SERVICE BULLETIN NO. 137A
Supersedes SB No. 137

DATE: June 22, 1973
SUBJECT: Engine Mount Inspection
SERIALS AFFECTED: AA5-0175 through AA5-0290
TIME OF COMPLIANCE: Within 25 hours of operation

FIGURE 1. ENGINE MOUNT/INTAKE PIPE CLEARANCE INSPECTION
(LH shown, RH opposite)

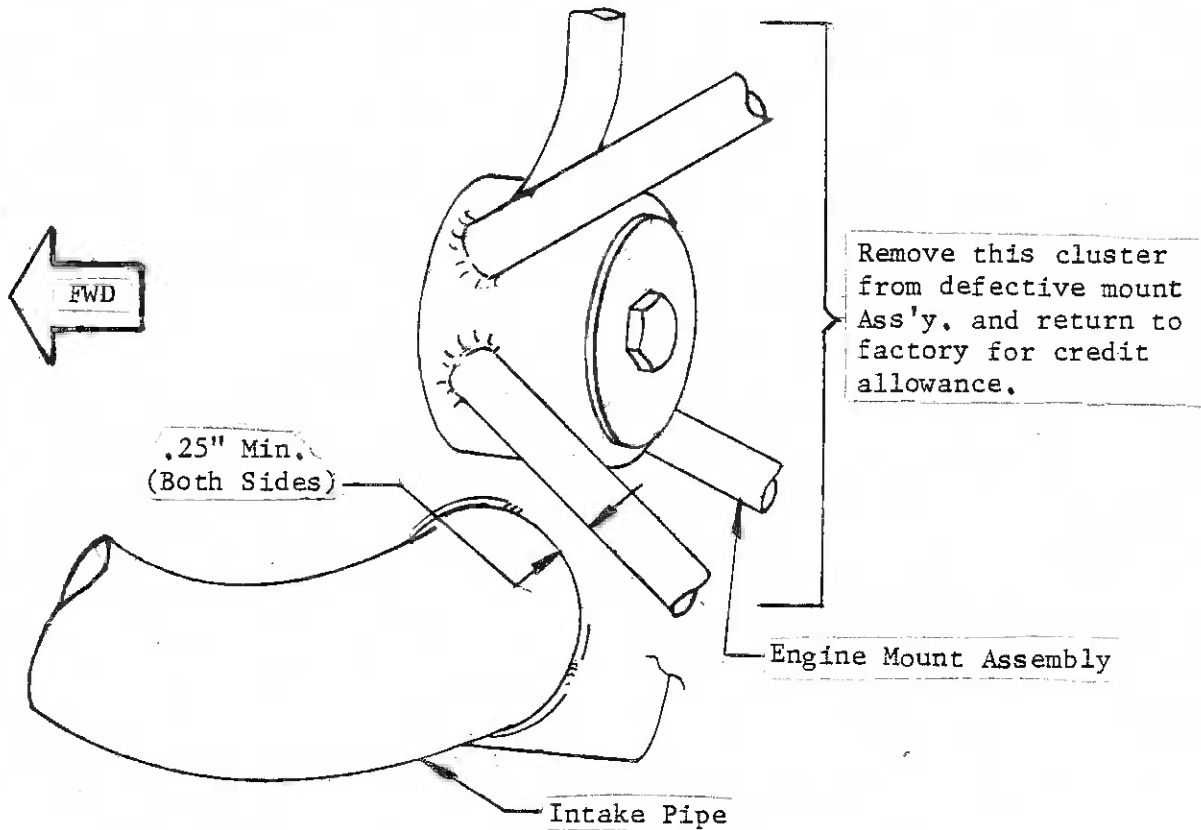
Inspect clearance between engine mount and #3 and #4 air intake pipes as shown on Figure 1. NOTE: CLEARANCE IS TO BE .25" MINIMUM.

If clearance is less than .25", but no evidence of physical contact between the engine mount and the air intake pipes exists, the aircraft may be returned to service, but the engine mount must be replaced within 100 hours of operation or at the next scheduled inspection, whichever occurs first.

If clearance is less than .25" and evidence of physical contact between the engine mount and air intake pipe exists, the engine mount must be replaced within 10 hours of operation and the intake pipe checked for cracks before further flight. Replace intake pipe before further flight if required.

If clearance is .25" or greater, no further action is required and the aircraft may be returned to service.
